**QSA Global, Inc.**

Mr. Bernard White, Senior Project Manager  
U.S. Nuclear Regulatory Commission  
Office of Nuclear Material Safety and Safeguards  
Division of Spent Fuel Management  
11555 Rockville Pike  
One White Flint  
Rockville, MD 20852

Docket : 71-9357  
TAC No.: L25122

The following is submitted in response to your letter for additional information dated 5/22/17. In response to your RAI questions we provide the following additional information:

Figure 1  
Sentry 110 Depleted Uranium (DU) Shield X-Section

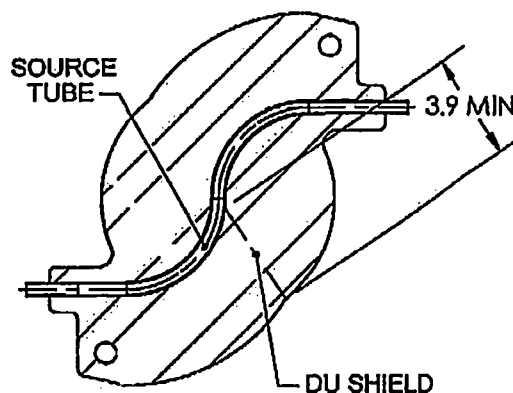
*Provide tolerances or justification for the choice of the reference dimensions on drawing R86000, sheet 9, Revision T.*

*In its response dated October 4, 2016, to the NRC request for additional information dated September 6, 2016, the QSA Global stated that it relied on acceptance criteria in Section 8.1.6 of the SAR to determine acceptability of the shield assembly, sometimes with the use of supplemental shielding. However, the applicant's acceptance criteria is not consistent with the dose rates provided in Tables 5.1a-g in the SAR dated November 18, 2015. While staff understands that certain dimensions are difficult to precisely measure, there does not appear to be a correlation between an actual depleted uranium (DU) shield thickness in the prototype tested and the measured dose rates. Staff would use an actual or minimum shield thickness as a point of reference for its confirmatory analysis.*

*Prior revisions had the same numeric value for the dimensions, but the applicant had labelled them as minimum. This practice is consistent with the criteria in NUREG 1609, "Standard Review Plan for Transportation Packages for Radioactive Material." The Standard Review Plan for Transportation Packages states that any analysis should rely on dimensions and material properties that maximize the external dose rates. The applicant's prior drawings supported confirmatory analysis consistent with these conservative principles. However, the applicant's use of reference dimensions, without further justification, is not.*

In summary, the depleted uranium (DU) shields used in these transport packages are free-form shaped assemblies made by a casting process with inherent variability.

The free-form geometry results in a variable thickness throughout the shield where the minimum thickness might only be present as one small spot or section in the shield geometry. Due to the free-form shape, the minimum thickness is nearly impossible to locate and if found can only be verified by destroying the shield for measurement.

Other shield dimensions are affected by the inherent variability of the casting process. This variability is caused by many factors, such as non-uniform shrinkage of the cast shape when it cools, source tube movement and distortion from the molten DU as it surrounds the tube during the DU pouring process, and occasional density changes in the DU from impurities in the poured material.

Natural variability in the casting process can produce shields that are outside the normal, expected tolerances for the "REF" dimensions on the drawing R86000 Rev T. These dimensional variations have no adverse impact on the package so long as the total shield weight is not exceeded per the drawings, and the final acceptance radiation profile surveys for the package comply with 10 CFR 71.47(a). When these requirements are met, the shield assembly is fully acceptable for use as a Type B container component.

The dimensions listed as "REF" on R86000 Revision T, sheet 9, are provided as "typical" shield dimensions based on the shield molds used to generate the finished shield assemblies. Acceptance for any individual Sentry package shield is based on each shield's physical shielding performance as demonstrated 100% by direct radiation profile measurement. The controls and evaluation process for the direct radiation profile measurement of these depleted uranium shields is specified in sections 5.4 and 8.1.6 of the SAR.
